Access Compliance Report Public Rights-of-Way (Curb Ramps)

Main Street: LOS PATRONES PKWY		Cross Street: OSO PKWY		Location:	SW
ADA ID: RPRK211021114301	Ramp Type: Type 1 - Perpendicular	Initial Pass/Fail: Pass	Overall Compliance: No	Severity Score:	2
Codes/Mitigation Info/Possible Solution			Field Measurements/Component Compliance

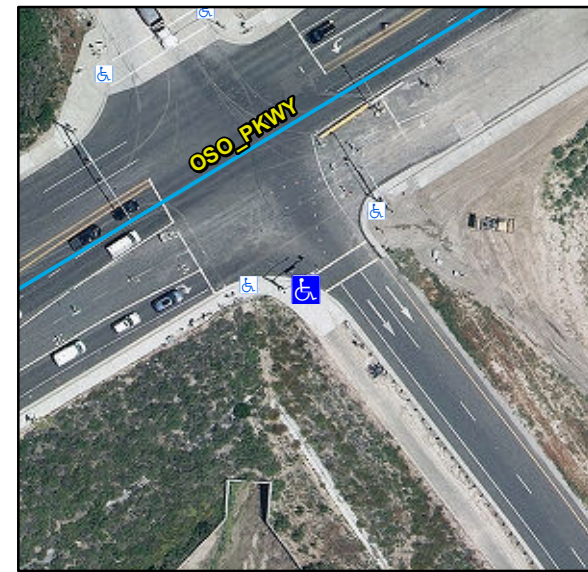
Remove & Replace Curb Slope.

R304.2.2, STD 1115
